RE: **37-DR-2021**

Hazel & Azure - Camelback
79P54 (Key Code)

The Planning & Development Services Division has completed the review of the above referenced development application submitted on 1/11/2022. The following **2nd Review Comments** represent the review performed by our team and is intended to provide you with guidance for compliance with city codes, policies, and guidelines related to this application.

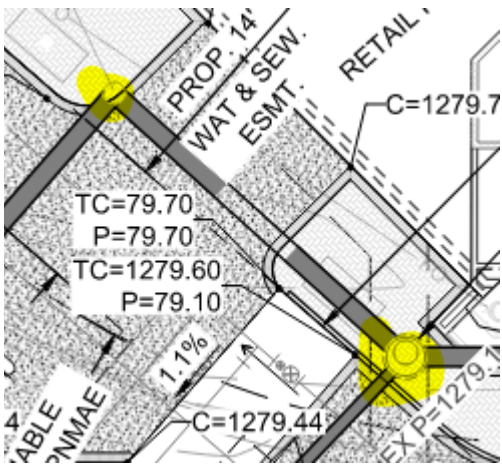
41. DSPM 2-1.309: Update case plans to comply with following refuse requirements: **Addressed.**

a. Building A

- (1) 60’ horizontal clearance in from of horizontal compactor
- (2) Add East Coolidge northern curb line and call out truck turning template into and out of horizontal compactor locations with 40’ long truck and 45’ turning radius.
- (3) Make and model of compactors used for site design.
- (4) 25’ vertical clearance @ compactor + truck servicing location.
- (5) Compactor capacity calculations accommodating 1 commercial container per 20 units and 1 container per 20, 000SF of commercial/retail/office.
- (6) Is recycle being provided? If so, please further define.
- (7) Provide refuse plan for SE building, per all DSPM requirements.

b. Building B

- (8) Maximum number of vertical compactor containers allowed is (4) – containers. Revise refuse from vertical to horizontal compactor meeting DSPM requirements.
- (9) Compactor capacity calculations accommodating 1 commercial container per 20 units and 1 container per 20, 000SF of commercial/retail/office.
- (10) Is recycle being provided? If so, please further define.

FIGURE 5-3.26 INTERSECTION DEPARTURE SIGHT DISTANCE REQUIREMENTS

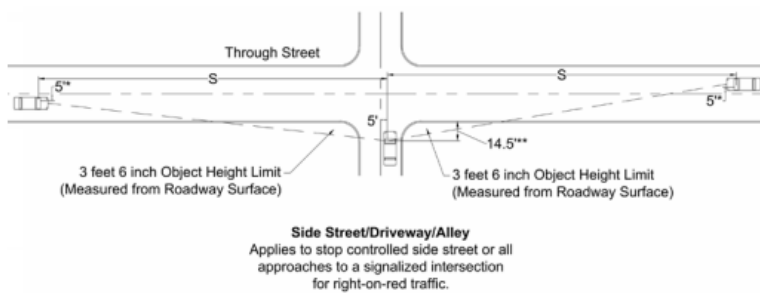
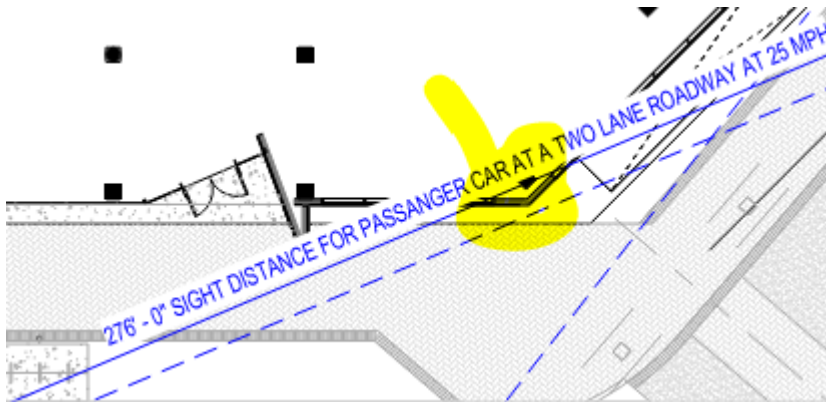
43. DSPM 5-3.123 D.: Update site plan with required site distance triangles meeting the requirements of these intersection sight distance requirements and: **THERE IS A CONFLICT BETWEEN THIS AND THE PROPOSED BUILDING, PLEASE MITIGATE BY REVISING BUILDING LAYOUT:**

- * 5 feet measured to nearest lane line or centerline.
 - ** 14.5 feet measured from face-of-curb or edge-of-travel way.
- S = Intersection sight distance in feet on driver's left and right for right turns, left turns and through traffic.
(See AASHTO Geometric Design of Highways and Streets for additional sight distance requirements)
(See, Appendix 5-3B for distance S)
